Our ref: 2021/2164/P
Please ask for:
Jennifer Walsh
Telephone: 0207 974
3500

**TOWN AND COUNTRY PLANNING (ENVIRONMENTAL IMPACT ASSESSMENT)
REGULATIONS 2017:**

RE: British Library Extension – request for EIA Scoping Opinion

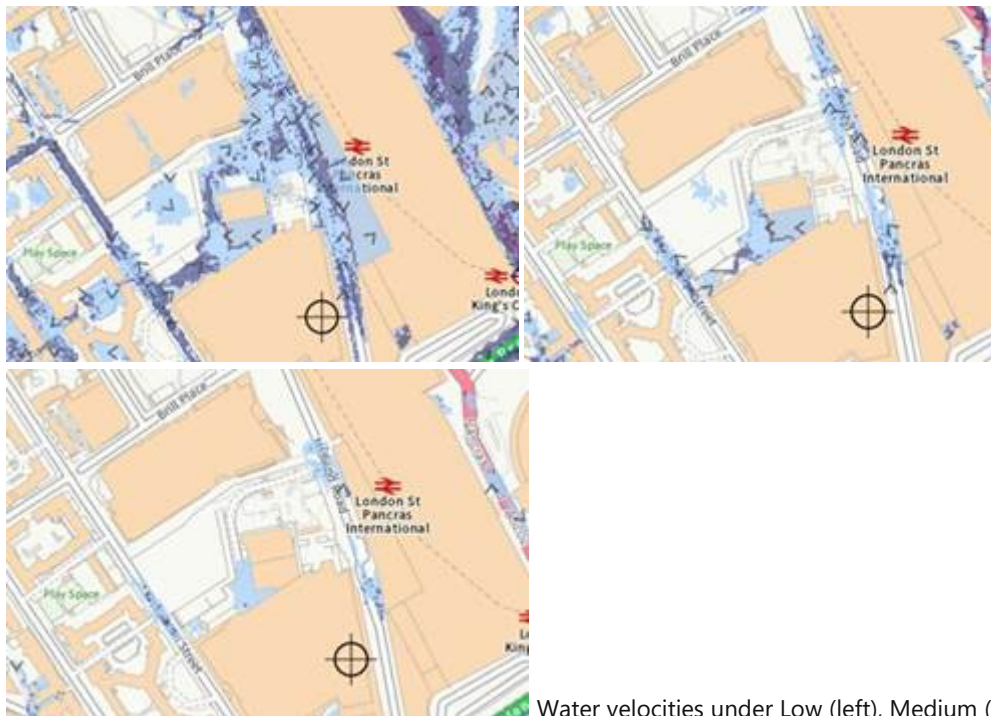
The maps above show that the very eastern part of the site overlaps with the King's Cross Local Flood Risk Zone. This is designated locally by the Strategic Flood Risk Assessment (Updated Maps 2015) for reasons of surface water flood risk. The scheme is therefore defined as an 'area at risk of flooding' which attracts particular planning requirements as stated in the Local Plan under Policy CC3, and guidance in CPG Water and Flooding. These include a Flood Risk Assessment.
